# CONSERVATION DEPARTMENT DETAILED AGENDA

Date: April 21, 2022

#### 1. 86 & 88 South Shore Drive-NOI-Raze and rebuild of a single family home and associated site work-DEP File# 300-XXXX

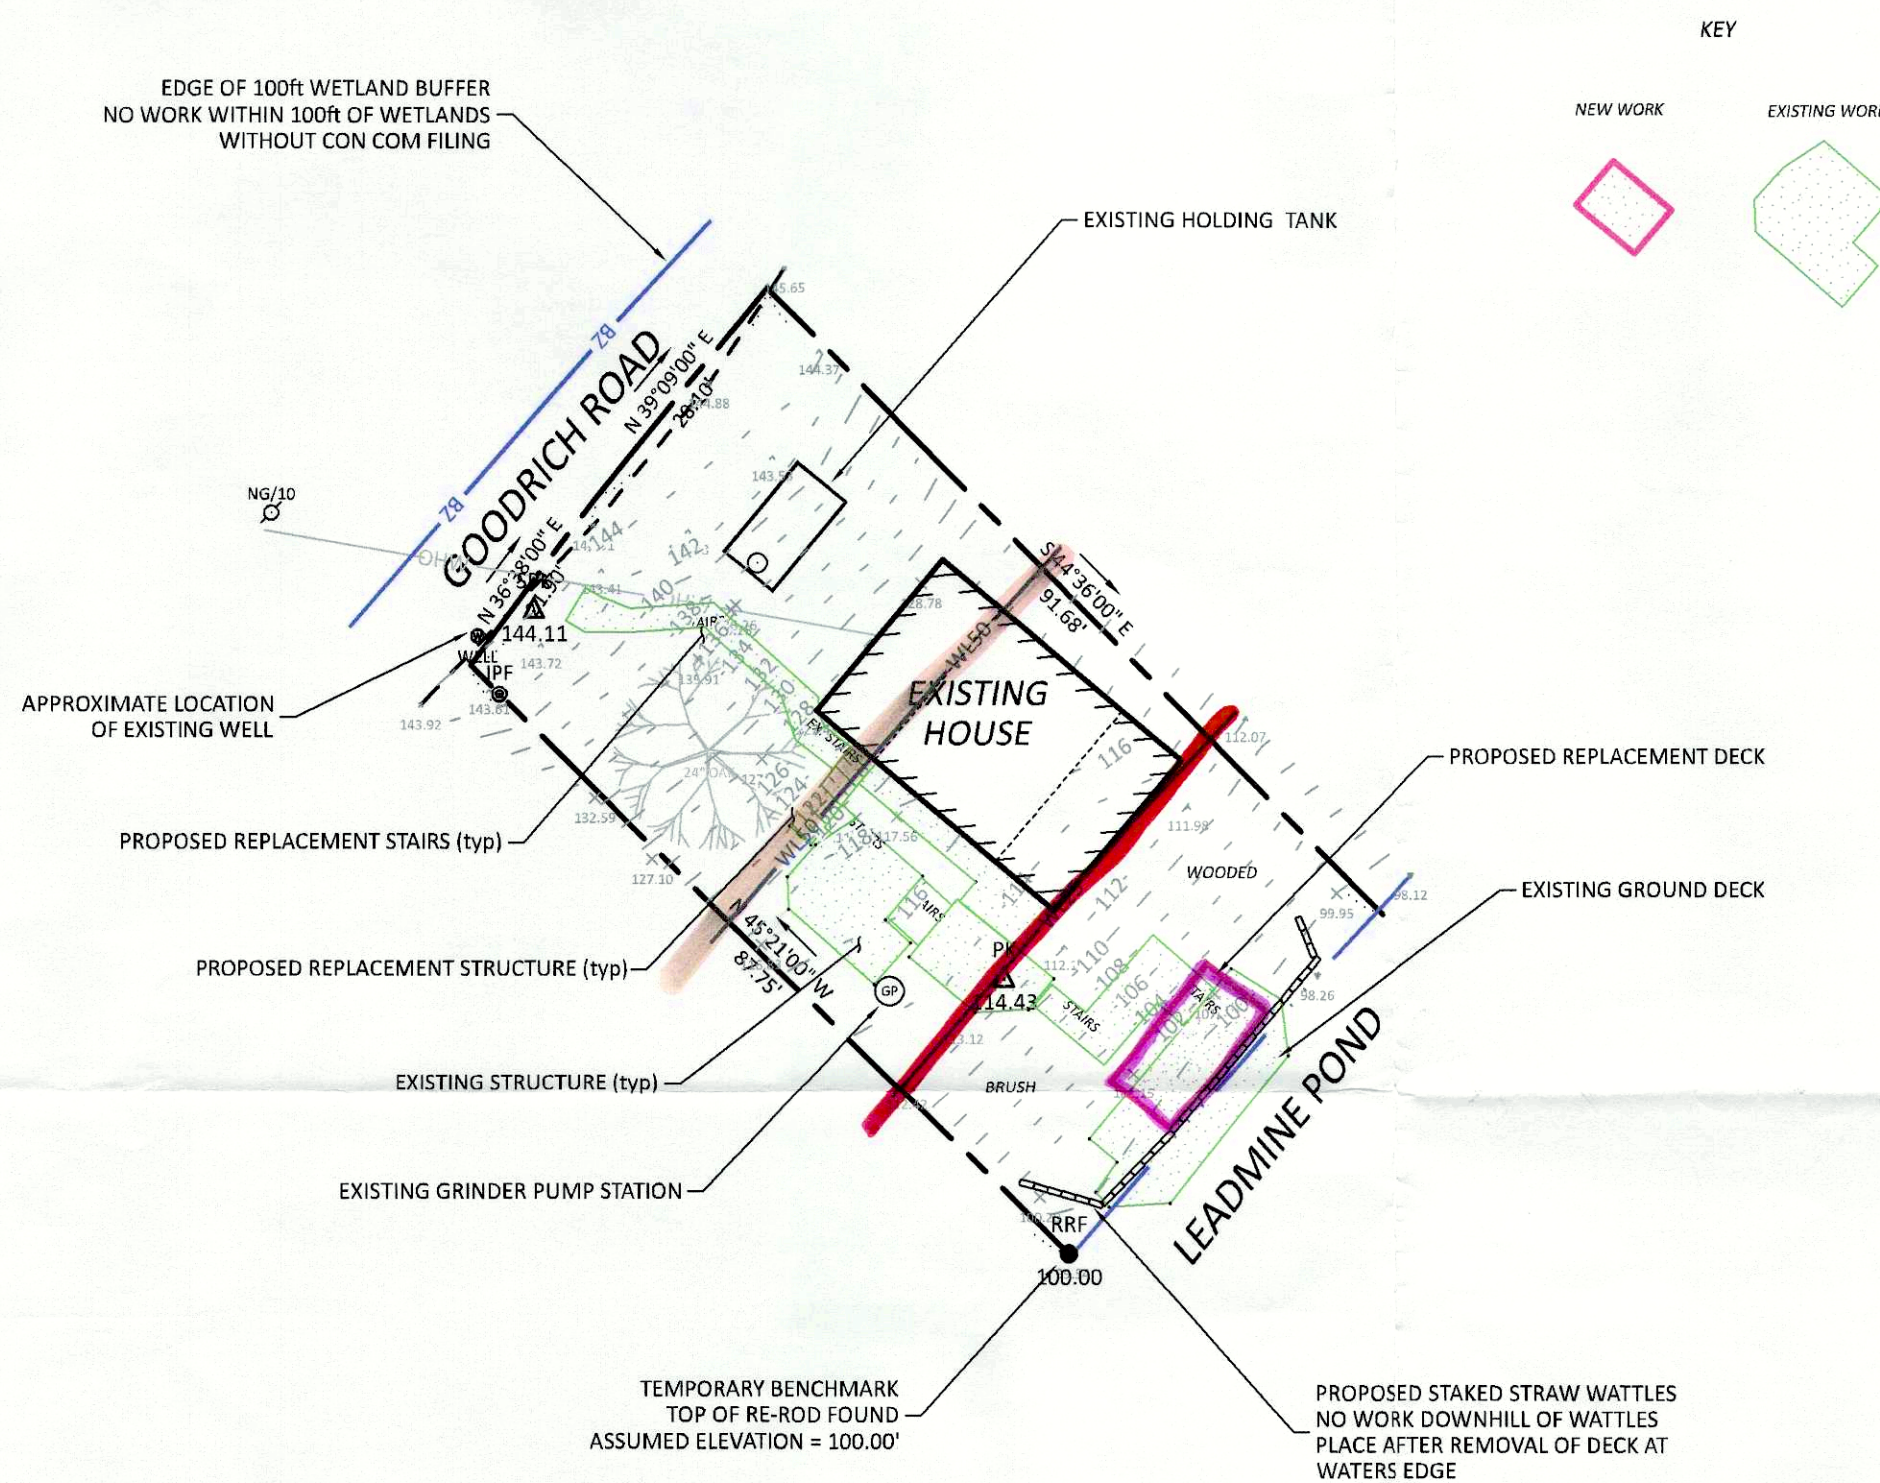
- DEP File # issued. No comments received.
  - Site visit performed.
  - Project is proposed within buffer zone to Bank.
  - Project is to replace existing structures in kind except the deck. The deck currently overhangs the lake and will be reduced in size to be located in buffer zone only. Minimal earth work is anticipated. Some footings may be replaced. All work to be done by hand. Footings do not currently exist in resource area nor are proposed.

- Staff Recommendations: Close hearing, staff recommend approval of the project through issuance of an OOC. with the following conditions:
    - Standard OOC conditions.

**PROPOSED SEPTIC SYSTEM**

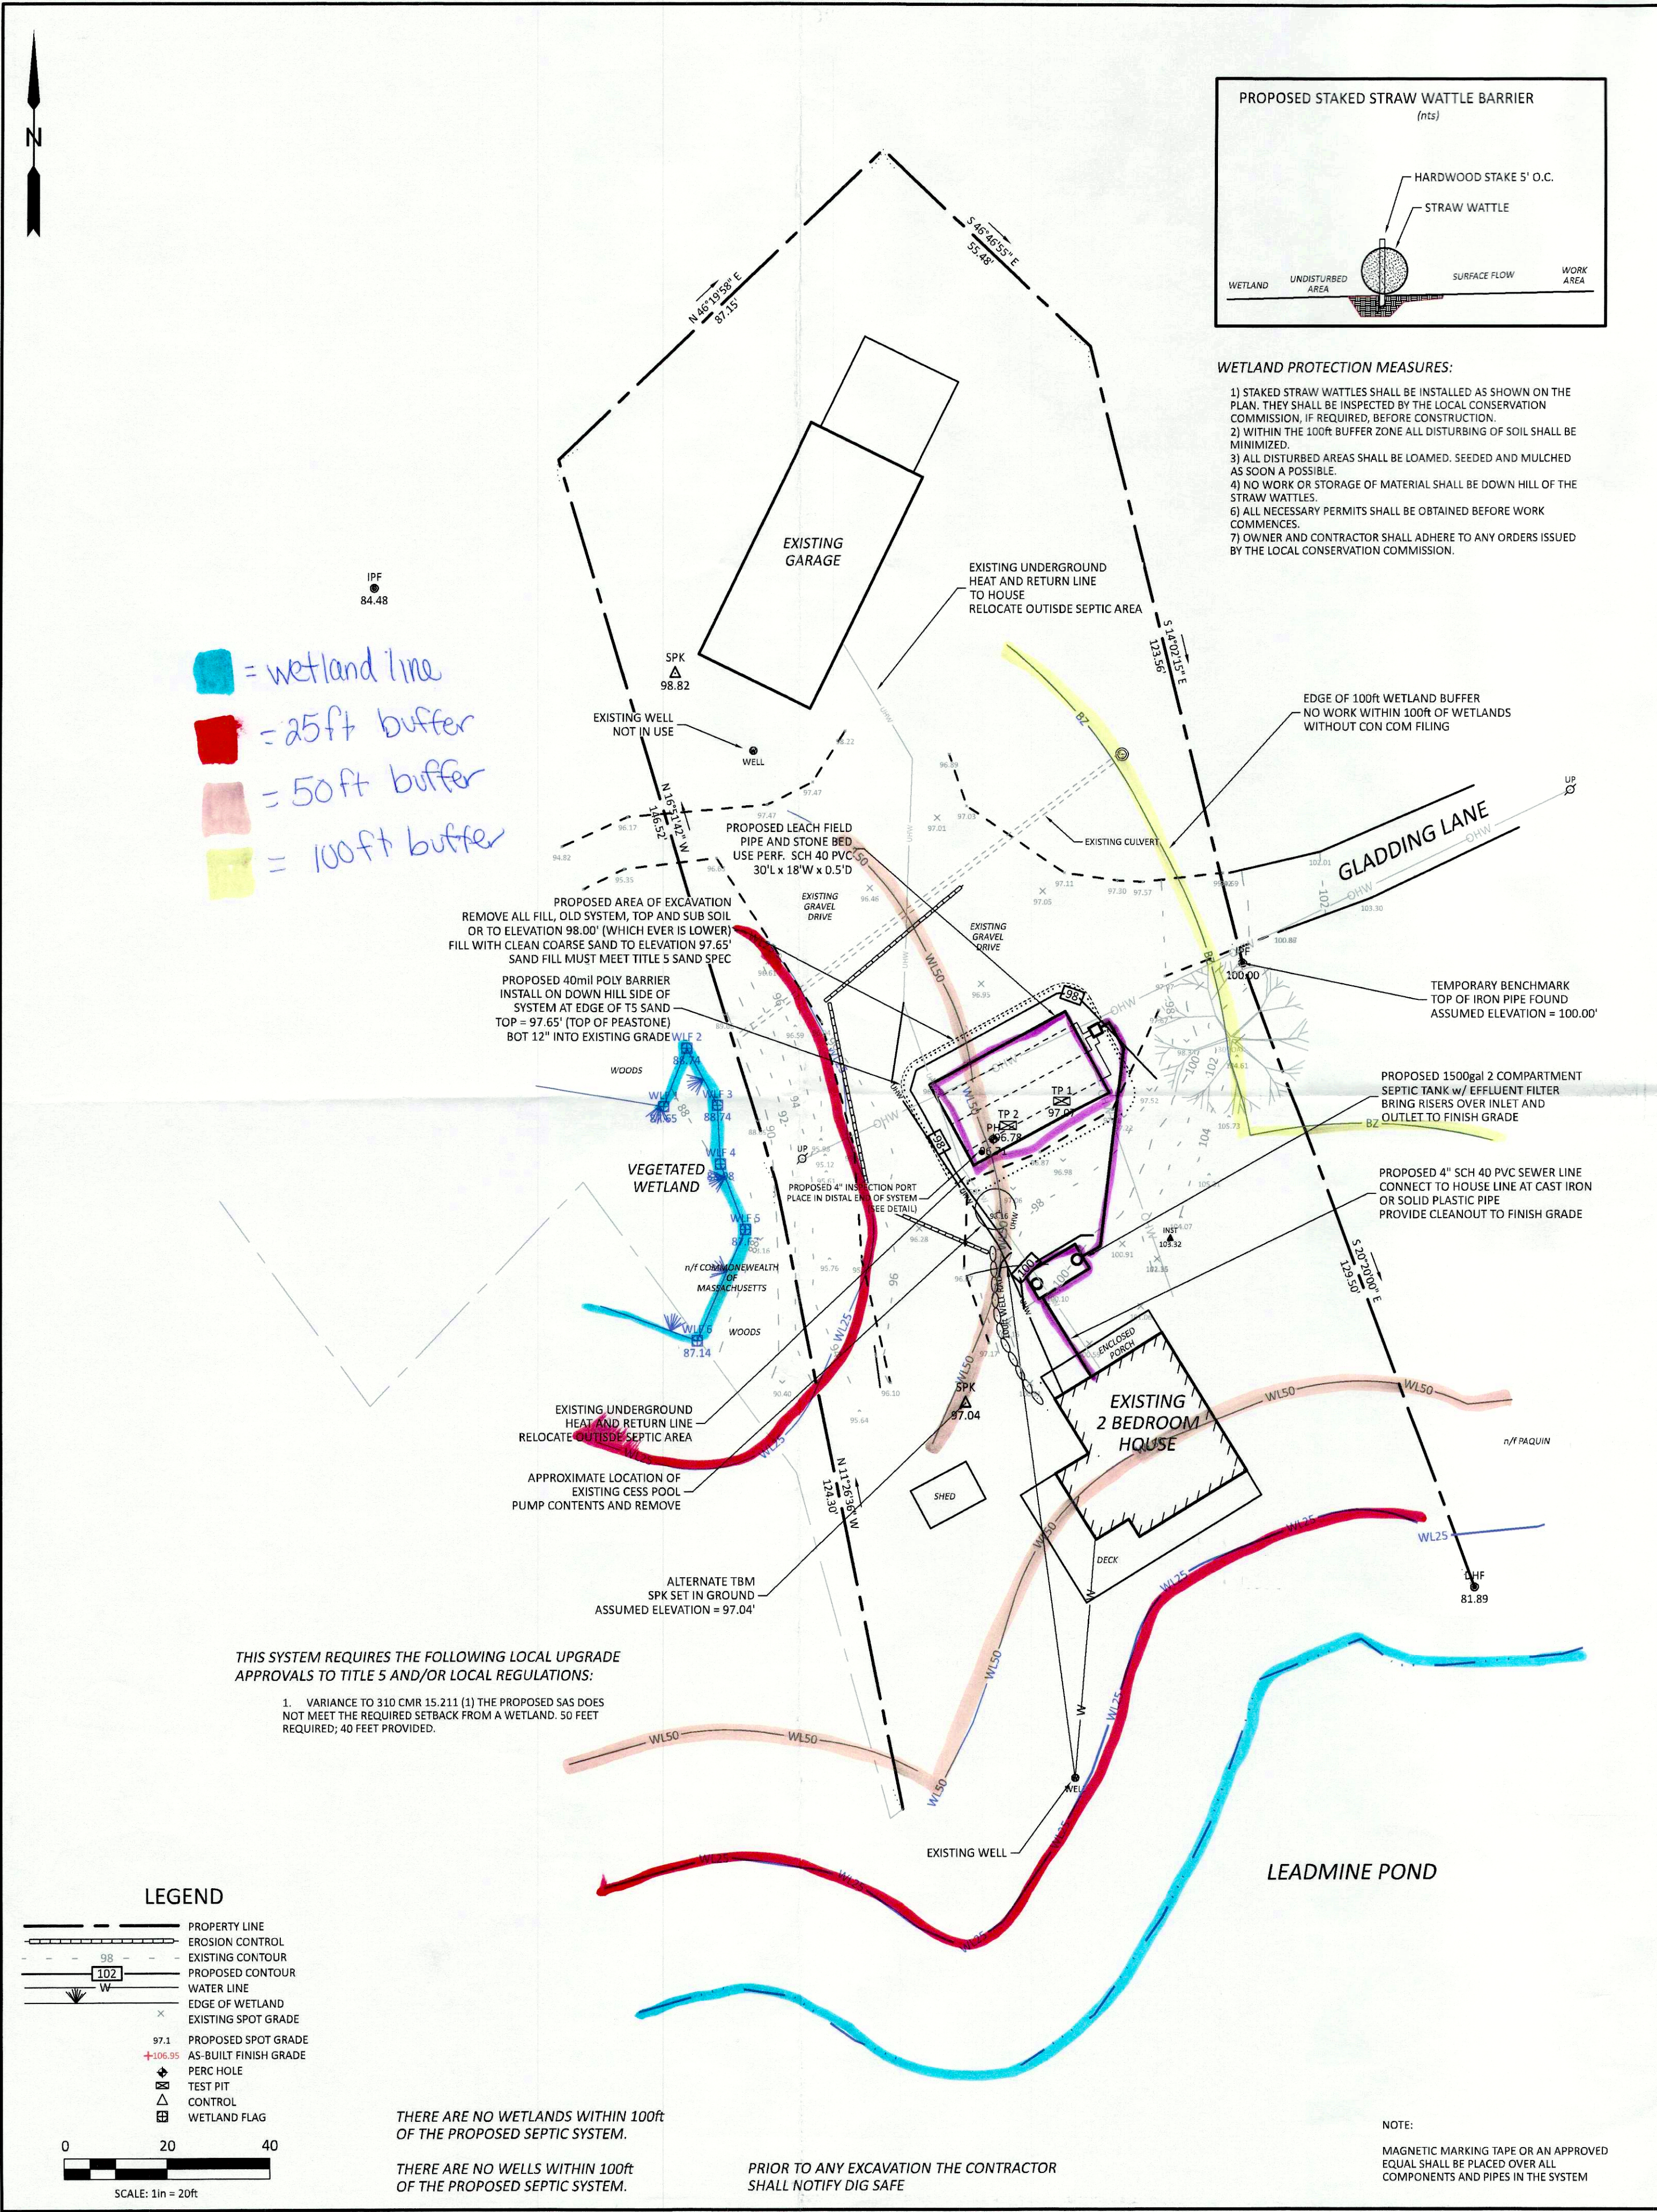
- System is proposed within 50 feet of a BVW. As proposed would require a variance. The system should be relocated outside of the 50 foot BZ as it appears possible.

- Disposing of leaves and ashes noted over the bank to the BVW. The ash must be removed. Representative informed on site of this.
  - Staff Recommendations: Continue hearing. Revise system location and remove ash. When appropriate, staff recommend approval of the project through issuance of an OOC. with the following conditions:

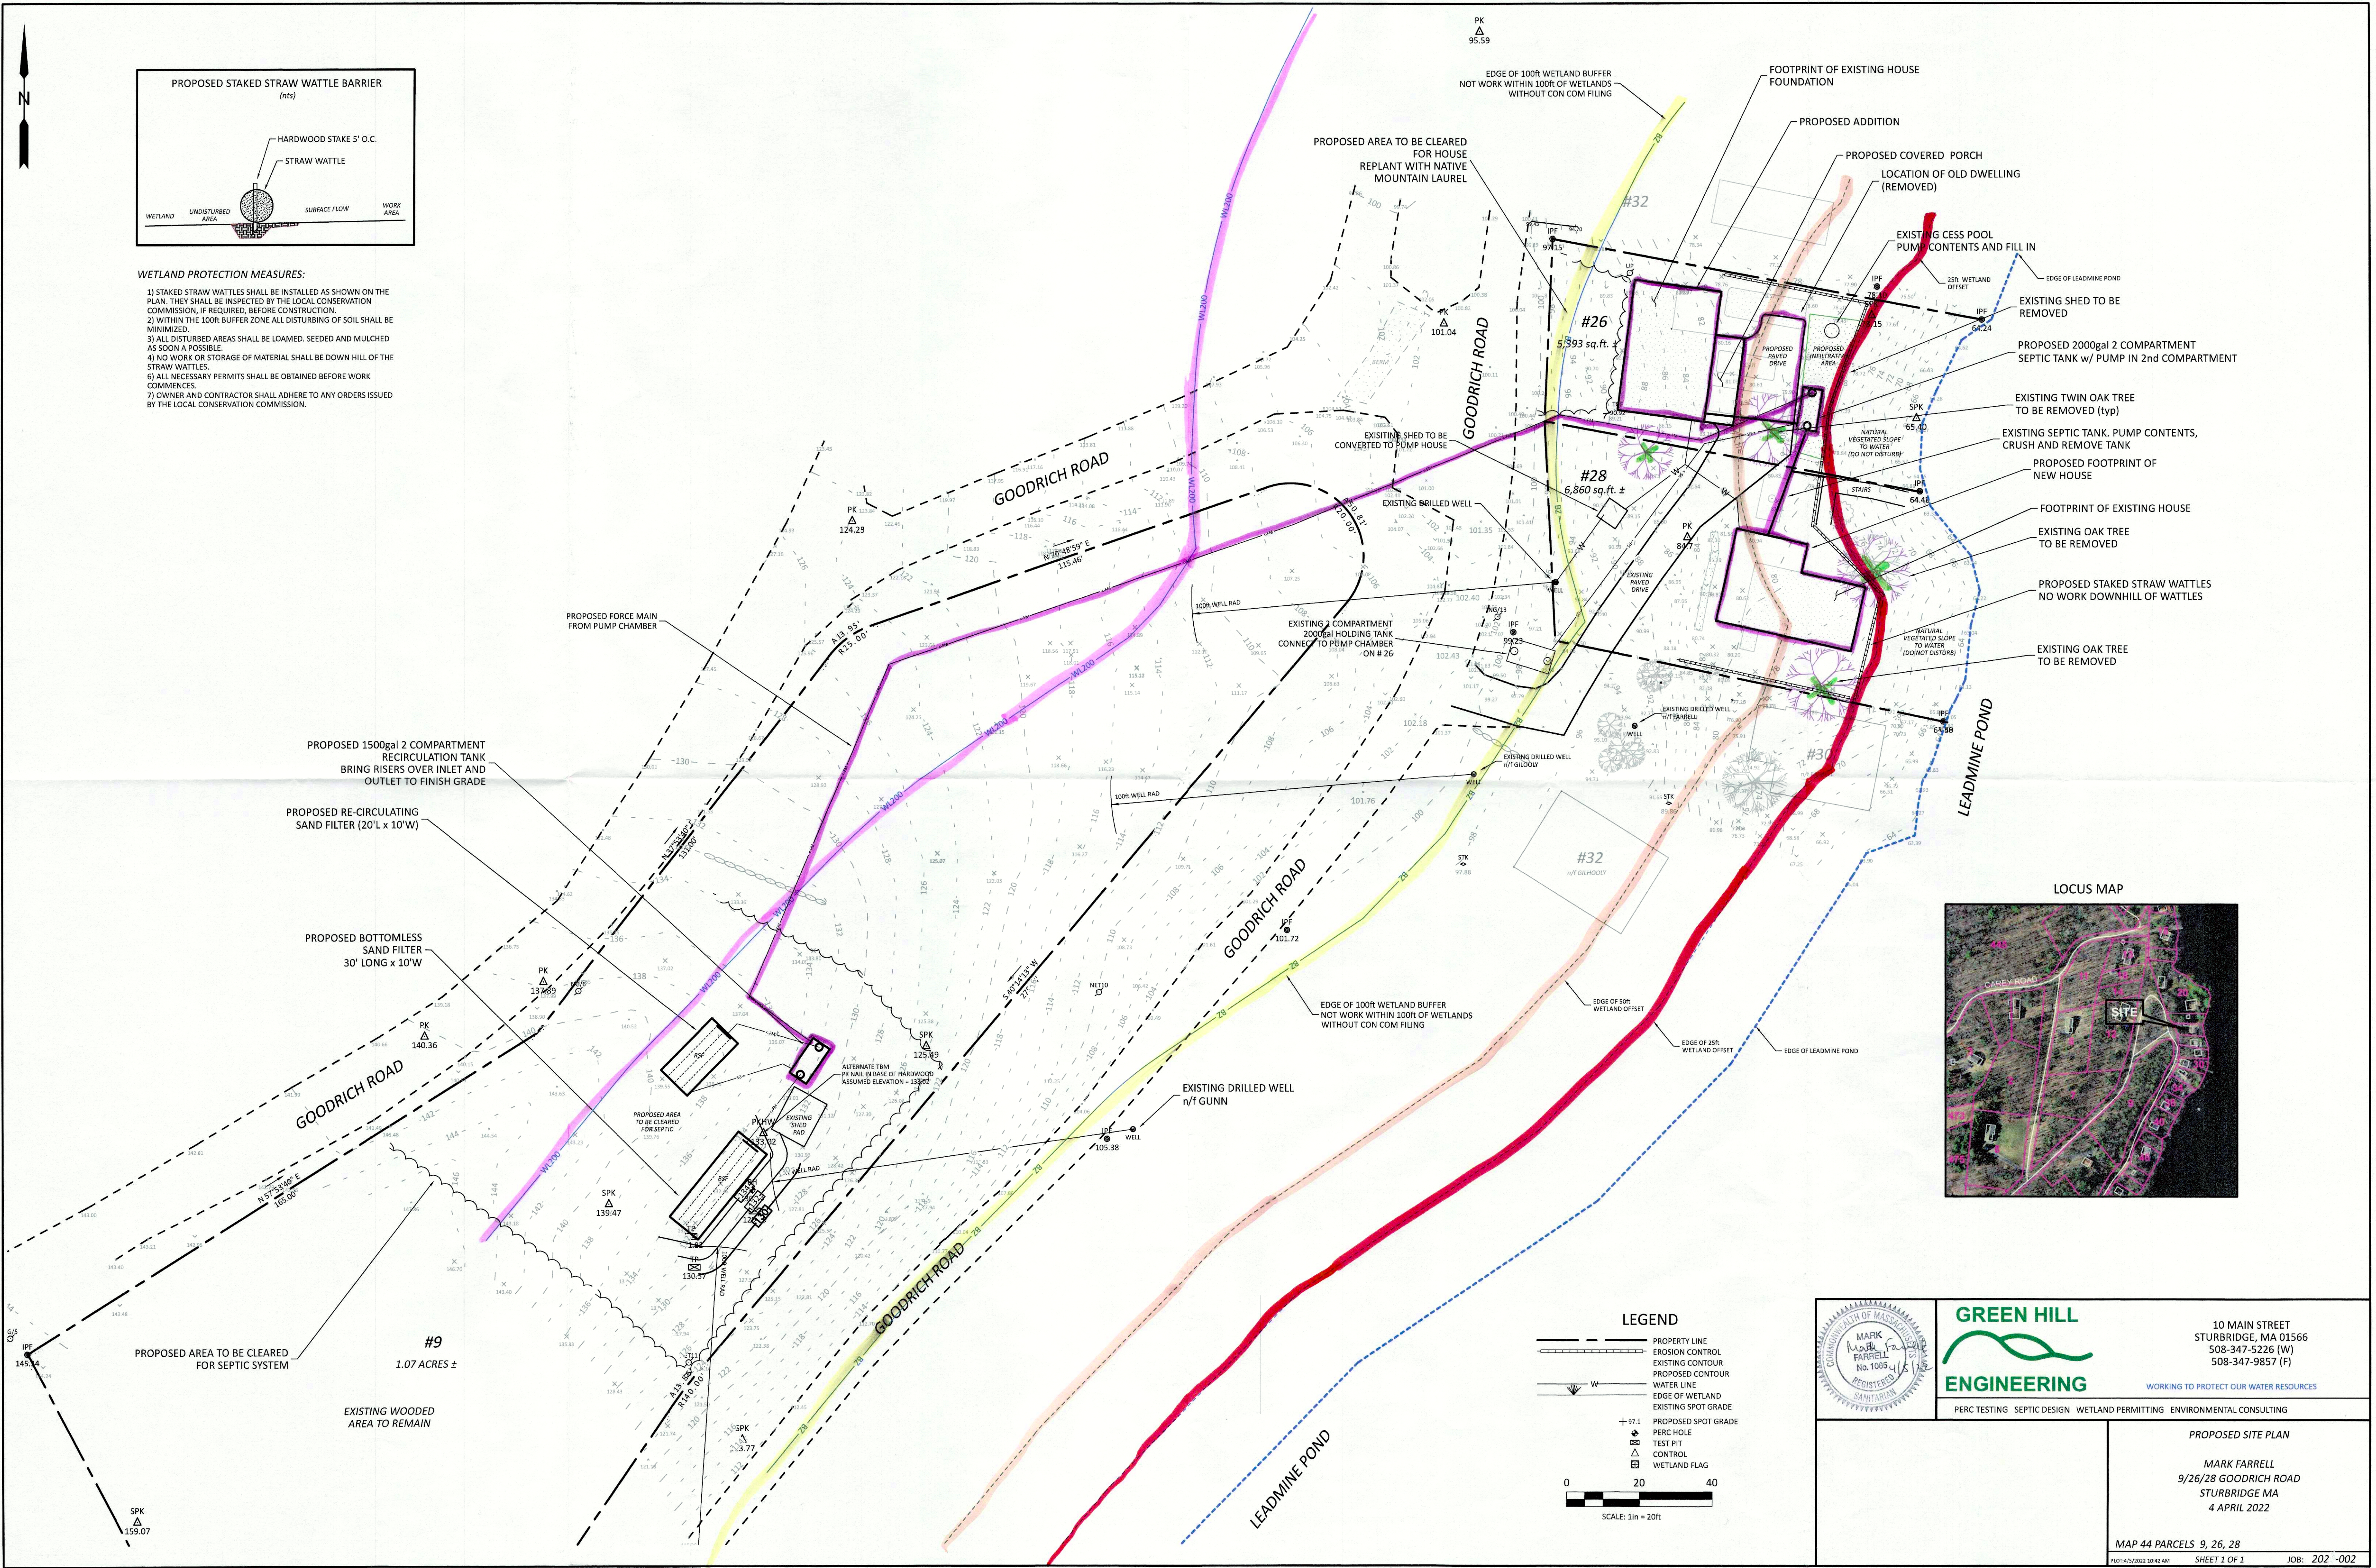
- Expansion noted within the 50 foot no new structure setback however an additional structure will be removed within the setback and an infiltration area is proposed there to manage stormwater. Additional information on the infiltration area is needed. The other structure will be located outside of the setback and primarily on an existing foundation. The septic will be shared among 3 properties within the 200 ft BZ but outside of the 100 ft BZ. 4 trees and a portion of another oak requested to be removed. Bank and site are well vegetated w/ substantial trees on shrubs along the bank. Additional native shrubs proposed.
- Staff Recommendations: Hearing must be continued as no DEP File # issued. Applicant to provide written alternatives to structure and compliance for waiver.
